APPENDIX N. PUBLIC COMMENT LETTERS AND RESPONSES

Appendix N-1: 2024 Plan Public Comment Letters and Responses

RE: Kern County Subbasin May 2024 Draft Groundwater Sustainability Plan - Subsidence

RE: Response to Western State Petroleum Association (WSPA) Comments Dated August 29, 2024, on the May 2024 Draft Groundwater Sustainability Plan (GSP), Kern County Subbasin, Related to Land Subsidence.

2019 California Aqueduct Plates MP 195-215

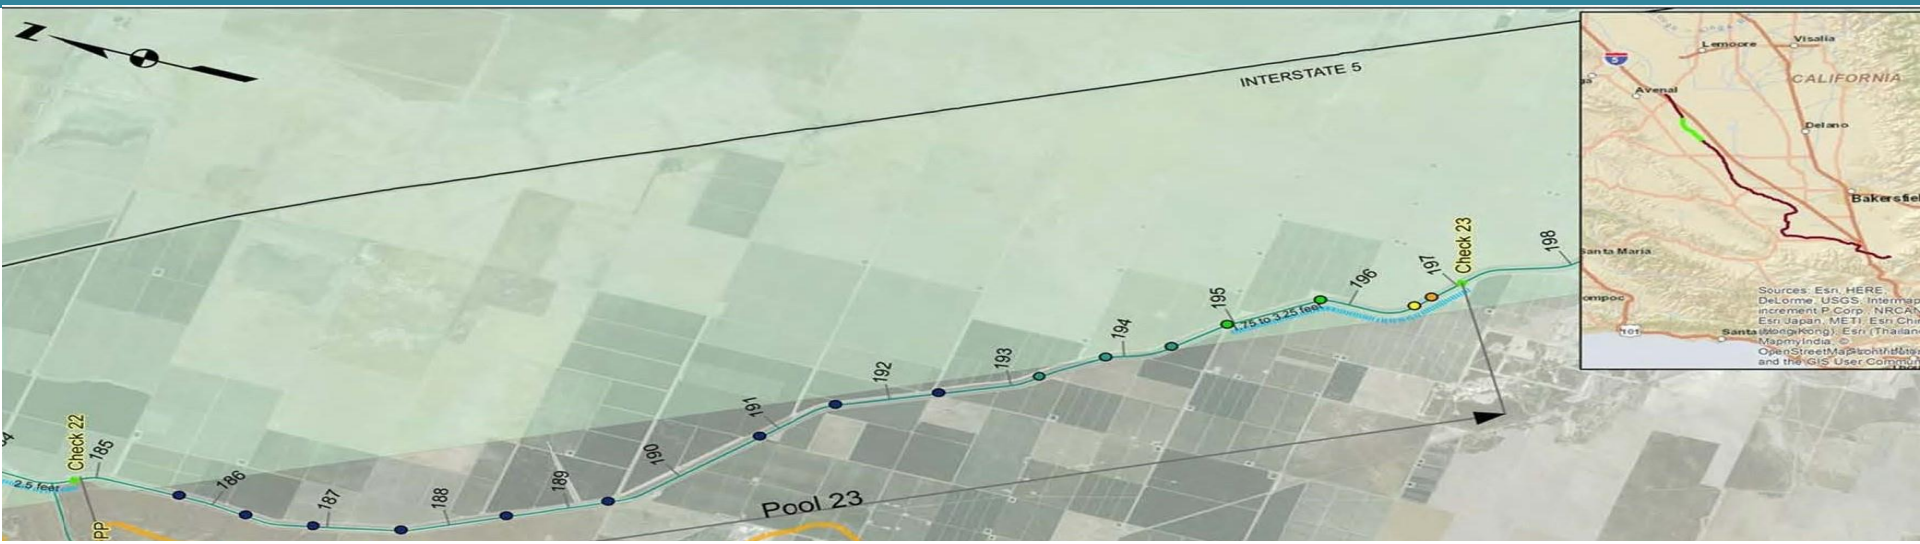
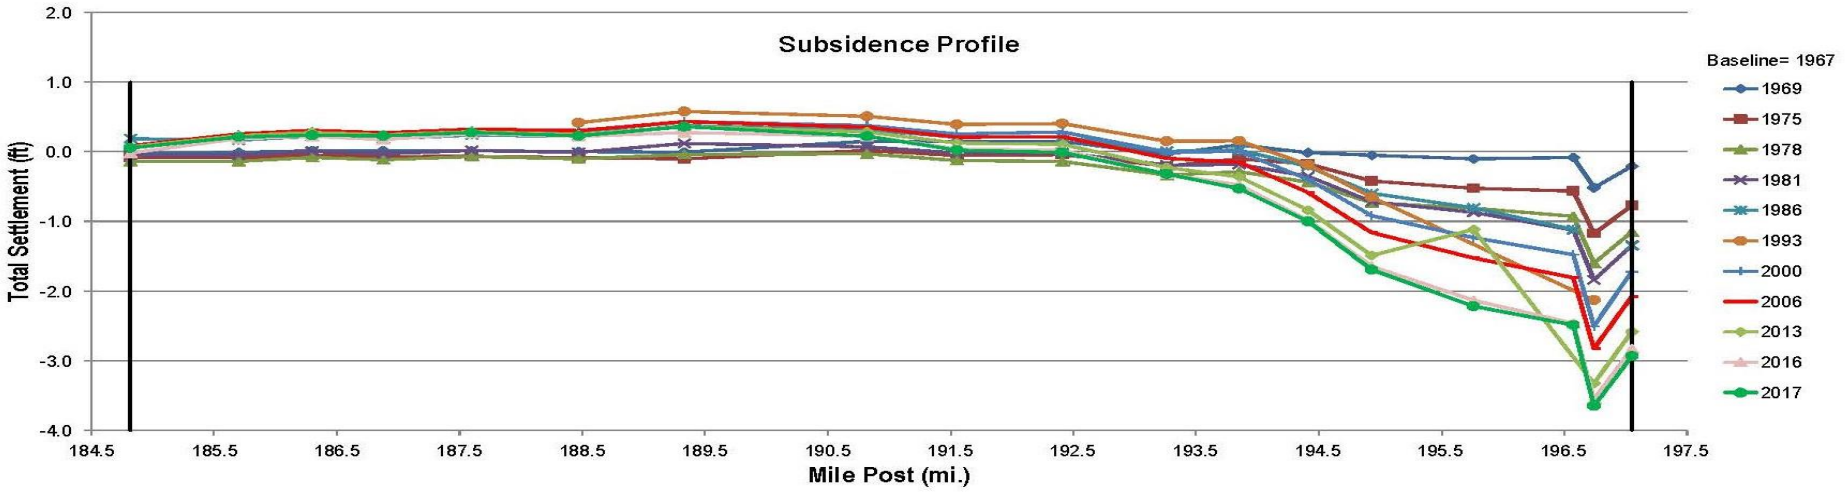
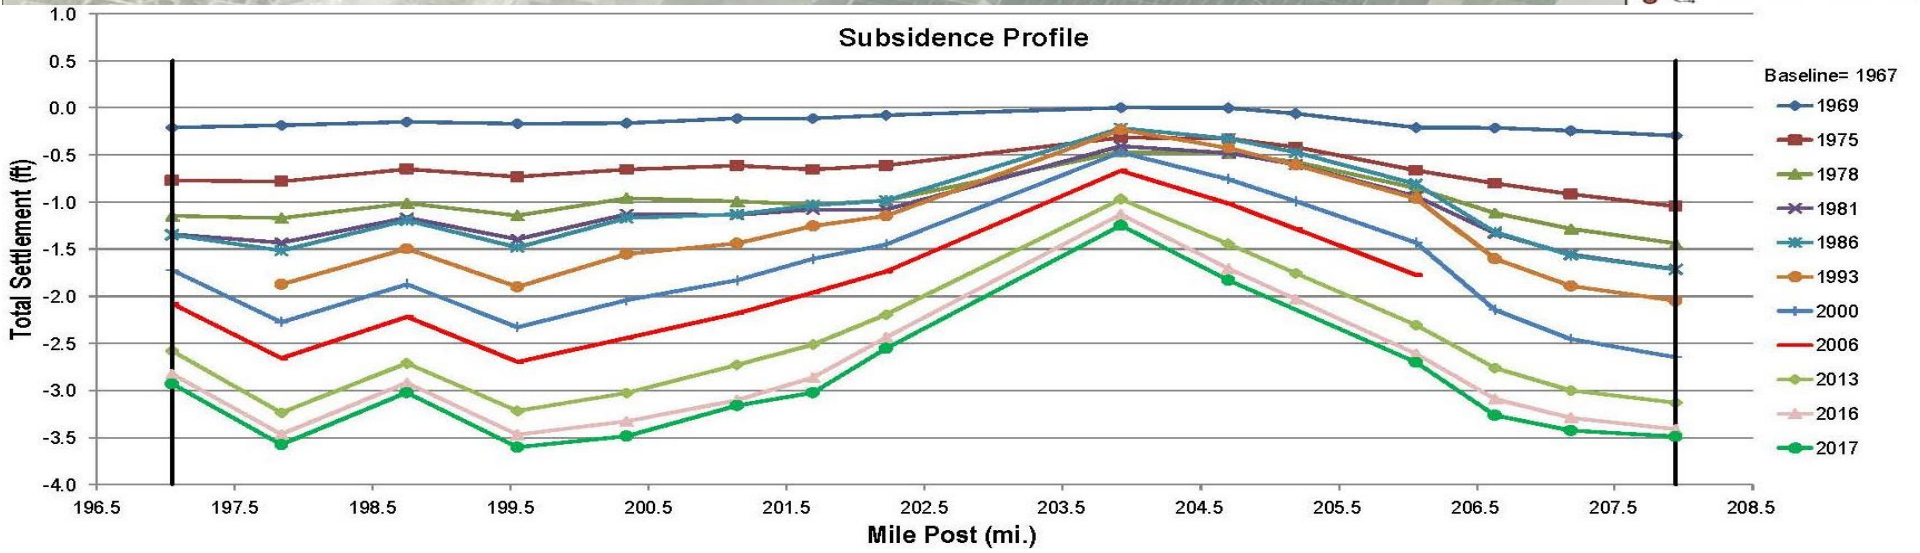
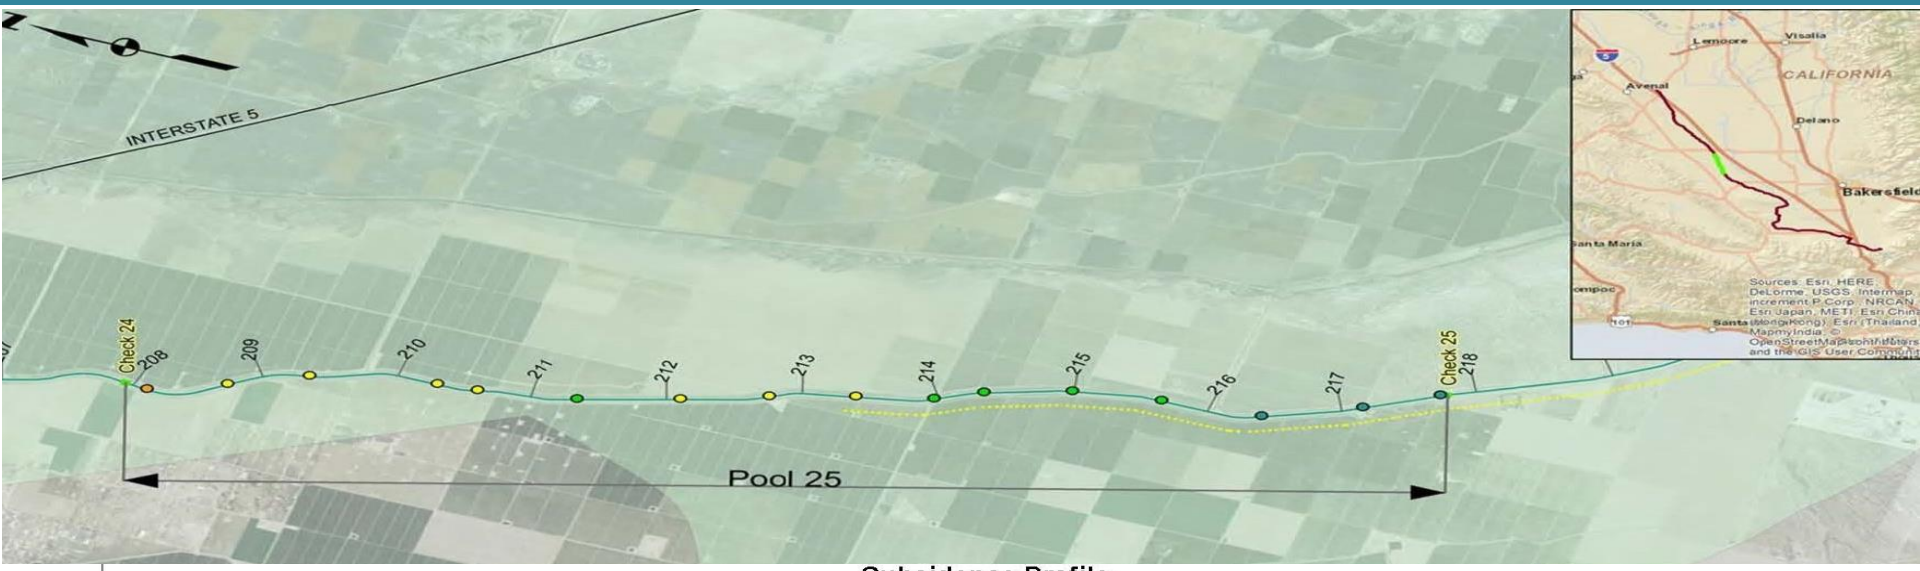
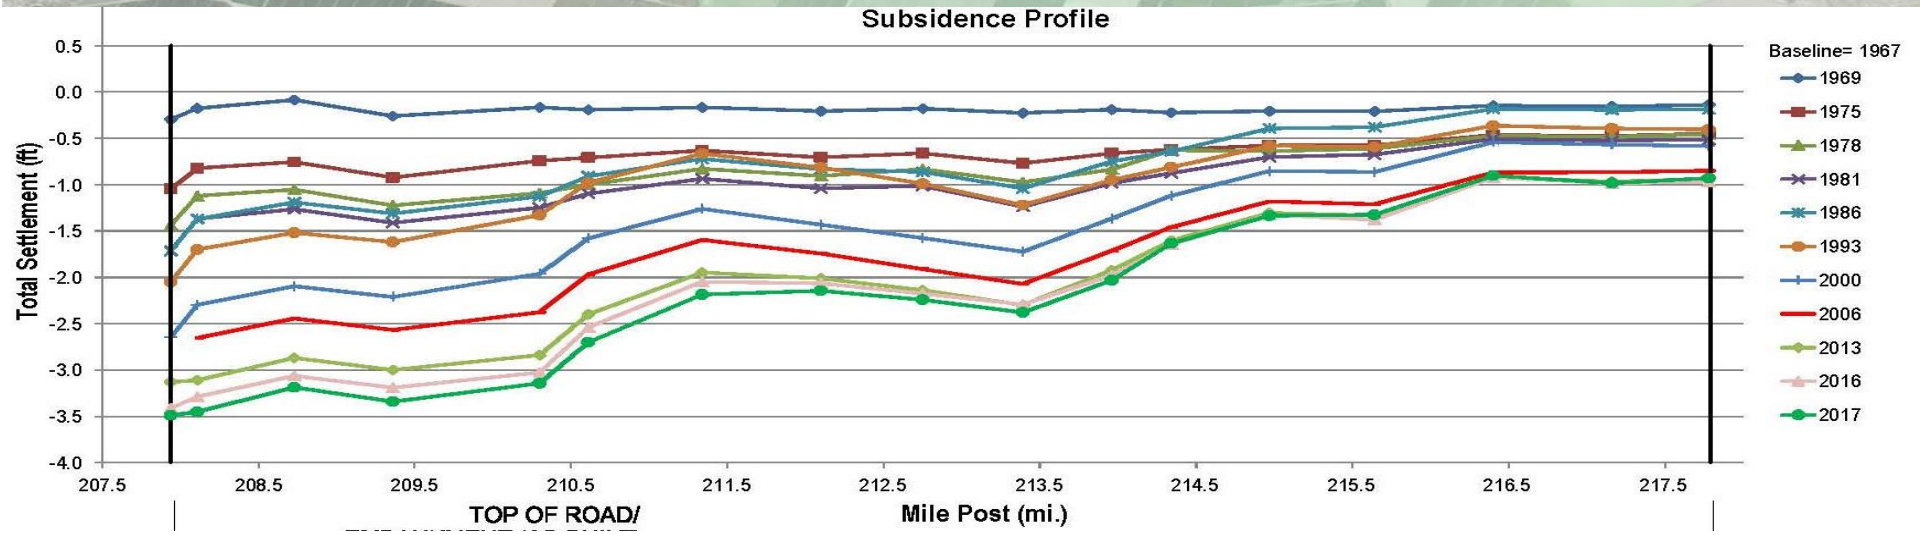
As noted in Response to **Comment # 5**, the DWR *2019 California Aqueduct Subsidence Study: Supplemental Report*, land subsidence survey profiles provided on Plates 12 through 14 (**Appendix D)** of this response letter) show that significantly increased rates of subsidence correlate to the beginning of Lost Hills Oil Field activities at approximately MP 195 and extend along the Lost Hill Oil Field to approximately MP 215 where oil activities currently end or are reduced. In regard to WSPA's comment that, "*the California Aqueduct Subsidence Study: Supplemental Report, relying on several lines of evidence (including an expanded 5 mile buffer zone on either side of the Aqueduct), concluded that, "subsidence associated with oilfield operations in the Lost Hills area is localized to the Lost Hills Oilfield and does not extend to the Aqueduct with subsidence background rates west of the Aqueduct*", new data show otherwise. In fact, CASP, in their December 21, 2023, response letter to WSPA state, "*These studies* [the 2017 California Aqueduct Subsidence Study and the subsequent 2019 supplemental California Aqueduct Subsidence Study] *contributed to the body of knowledge of subsidence along the Aqueduct. However, given the limited data and information on which these studies were based, it is important that the interpretations they contain* ***not be viewed as the definitive 'end of the story,' but rather an important step towards a collective understanding of the causes of subsidence affecting the California Aqueduct****."* (emphasis added)

Figure 8-71. Time Series for AOI-5 Track H-H'

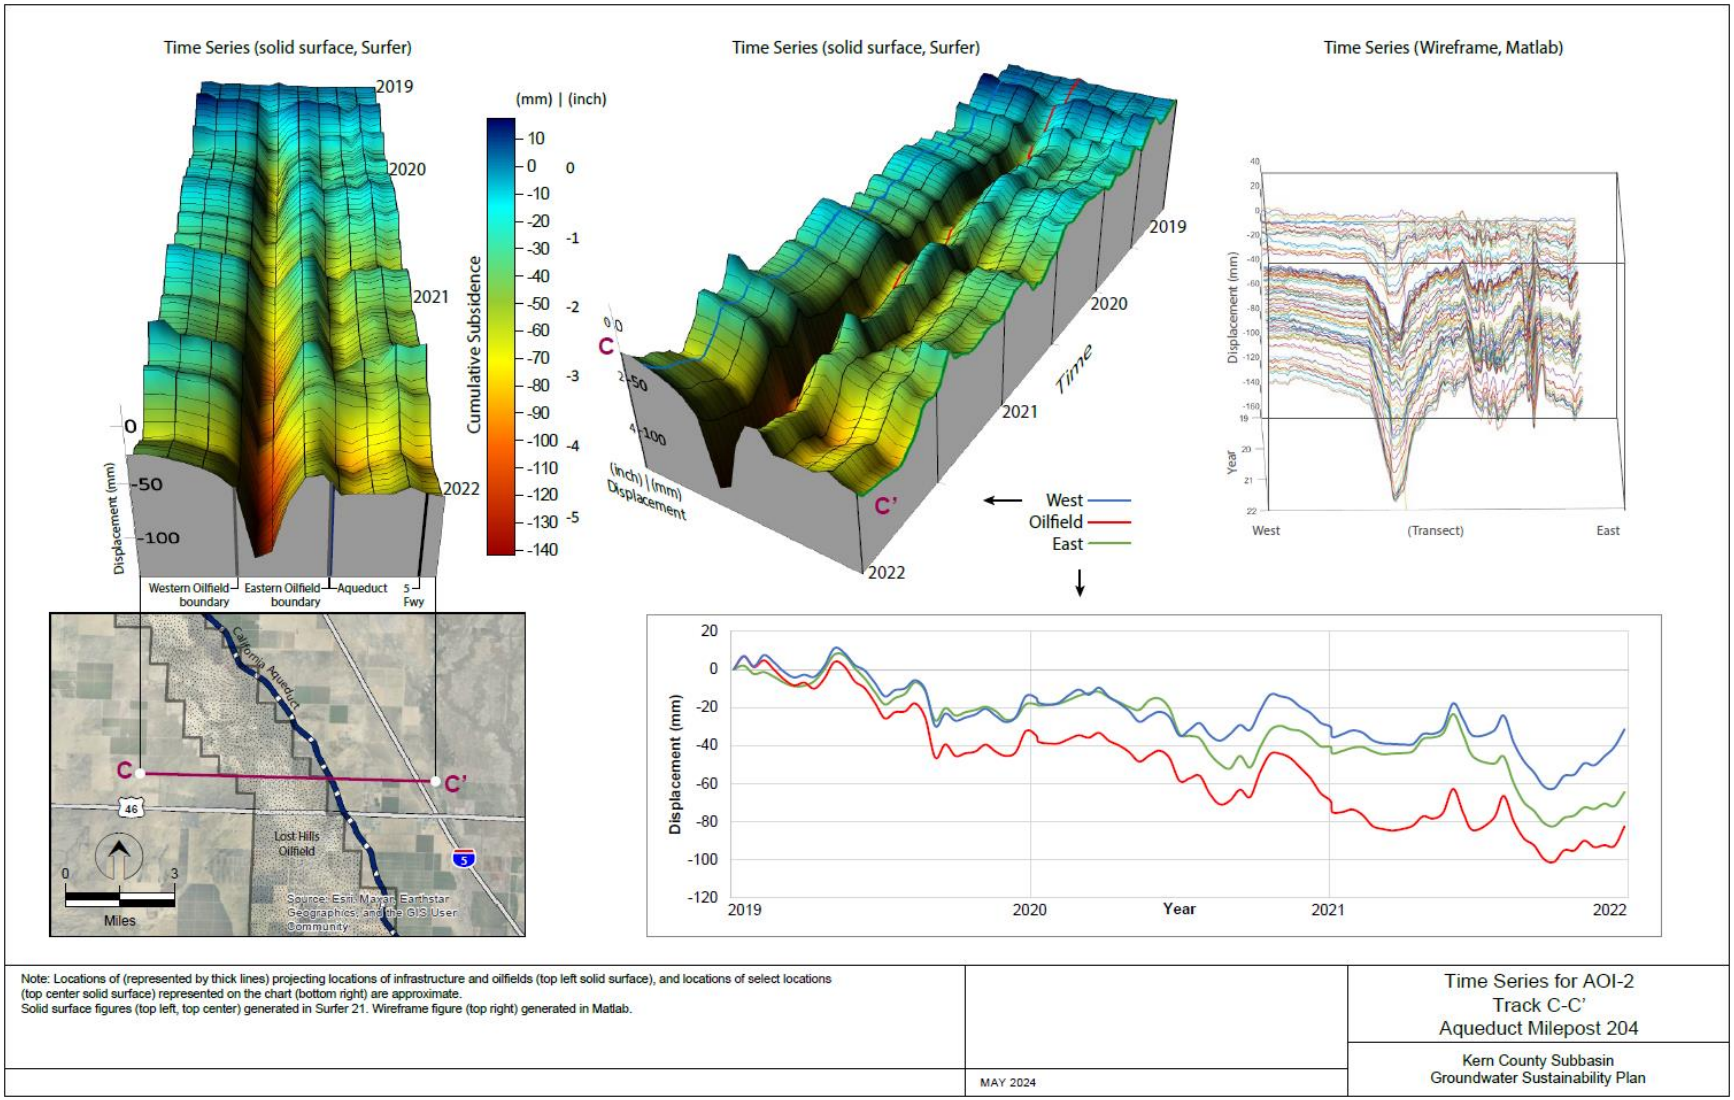
In the Subbasin 2024 Draft GSA Report, **Figure 8-71** provides an example of the InSAR time series signature for agricultural pumping (i.e., GSA-related). In this time series all the time series lines are in harmony and have a sine-wave shape indicative of seasonal pumping activities. Non-seasonal pumping, for example oilfield activities near Aqueduct MP 204, tend to exhibit a less sinuous pattern (i.e., noisy pattern) and a steeper declining slope reflecting non-seasonal (i.e., more sporadic) pumping. **Figure 8-66** in the 2024 GSP provides an example of a non-GSA time series signal (see also, (**Appendix E**) in this response letter). More detail is provided in Section 8.5 of the Subbasin 2024 Draft GSP Report. Based on the WSPA comment, the Subbasin will review **Section 8** of the Subbasin Draft 2024 GSP to ascertain if we can expand or further clarify the existing text in the Final 2024 GSP.

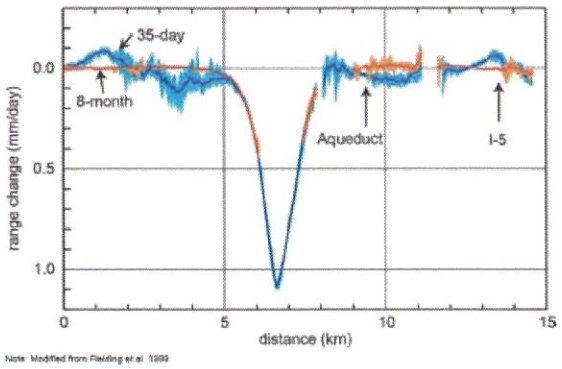
- As illustrated in the image below, the findings of the DWR 2019 Report, as well as the 2023 Earth Consultant International report and Chevron's own independent analysis confirm localized subsidence from Chevron's LHOF operations fully attenuates prior to reaching the Aqueduct and that another source or sources cause an eastward increasing subsidence observed between Chevron's LHOF operations and the Aqueduct.

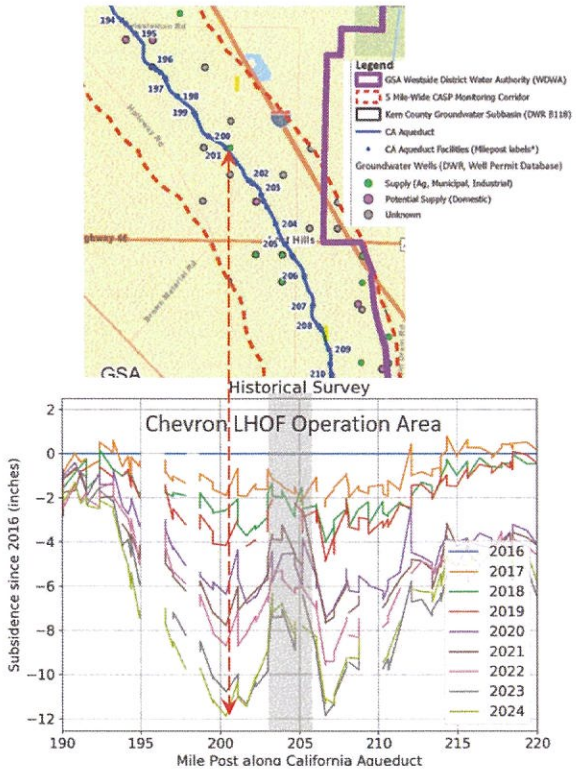
- The GSP's claim that there is limited to no groundwater being pumped for GSA-related purposes in the northwestern part of the Kern County Subbasin is inconsistent with available data. As noted in Section 5.6.1 of the June 2025 GSP, the GSAs have yet to complete the Subbasin-wide well inventory making any claims related to groundwater pumping in the northwestern part of the Subbasin premature. Moreover, groundwater monitoring well 21MW-5, screened between 565.8 - 595.0 ft below ground surface (below the Corcoran clay) just to the east of the Aqueduct MP 202 to monitor the cleanup activities associated with a former percolation pond, shows groundwater depths declined by roughly 2.8 ft/yr between 2015 and 2023. This data shows that groundwater extraction, unassociated with the LHOF is occurring. Similarly, the June 2025 GSP Appendix N figure at page 56, which identifies groundwater supply wells in the vicinity of the Aqueduct, includes a supply well at approximately MP 200, immediately adjacent to the Aqueduct as illustrated below. The June 2025 GSP does not provide any information on the draw down from this well or its general usage. Likewise, the figures show that surveyed Aqueduct subsidence is less between MP 203-206, which correlates with less agricultural activities in the vicinity of the Aqueduct east of the primary area of Chevron's LHOF operations.

Contrary to the GSAs' claims, these examples show that there is a GSA-related subsidence factor (i.e., groundwater pumping) in the vicinity of the Aqueduct that needs to be evaluated

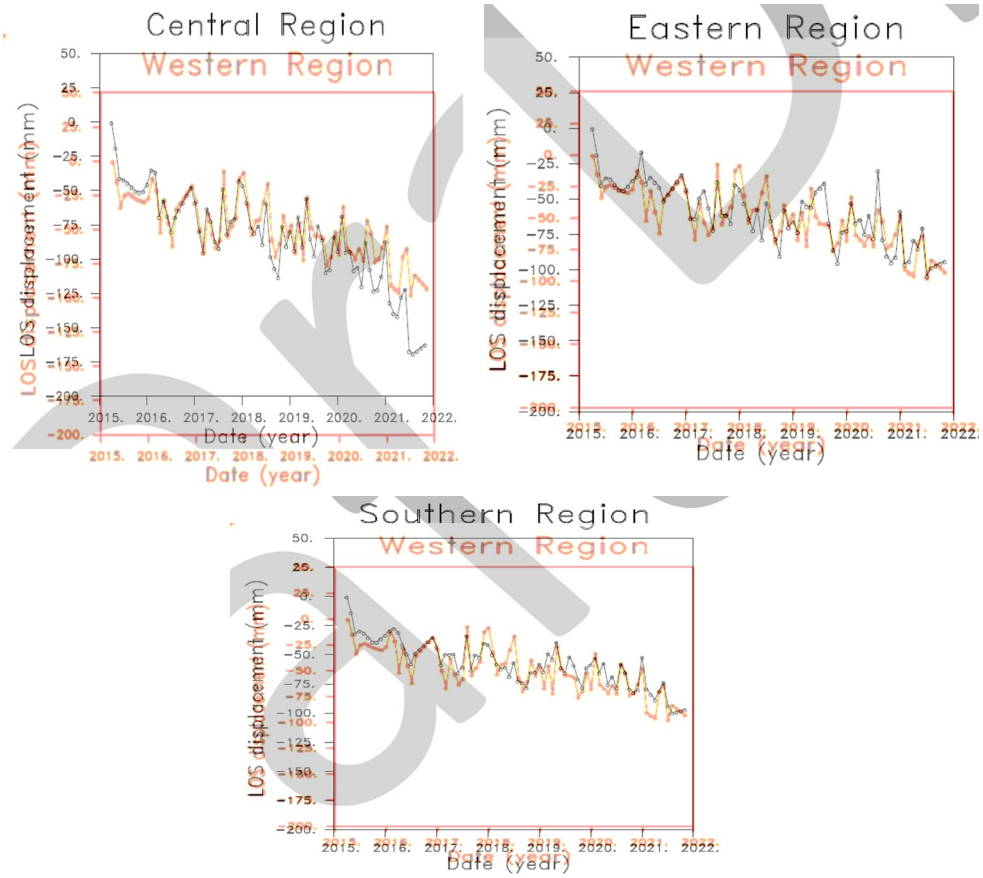
- GSAs' Response to WSPA Comment #4: The GSAs' claim that the ECI 2021 Report shows different subsidence trends in the Western Region of the Kern Subbasin than in other regions of the subbasin is belied by the data. Although the actual ECI report has not been publicly released, overlays from figure 4 of the ECI 2021 Report confirm there is little to no difference in the land subsidence signatures between the four regions, indicating that LHOF operations are not impacting regional subsidence observed in the Western Region.

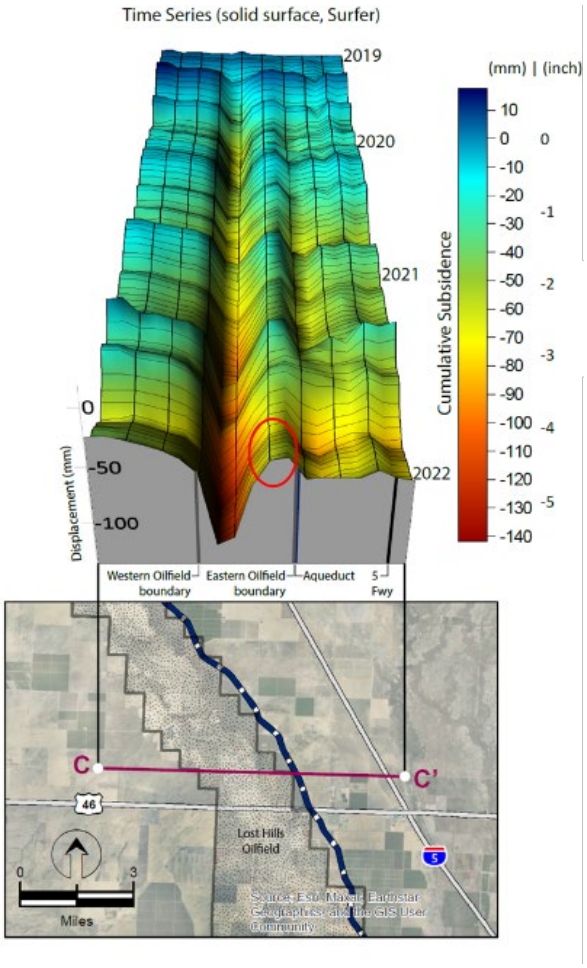
This conclusion, for example, is supported by figure 5c in the ECI 2023 Report[5] reproduced below, which shows that subsidence profile along Transect C-C' from the LHOF operation area to the Aqueduct. Subsidence decreases within a short distance from the LHOF operation area in both east and west directions. In the easterly direction, subsidence decreases to a minimum between the WSPA LHOF operator operational areas and then begins to increase again toward the Aqueduct. The two distinct subsidence troughs along Transect C-C', one localized in the

LHOF operation area and another one at the Aqueduct, indicate different causes of subsidence at the LHOF operation area and the Aqueduct.
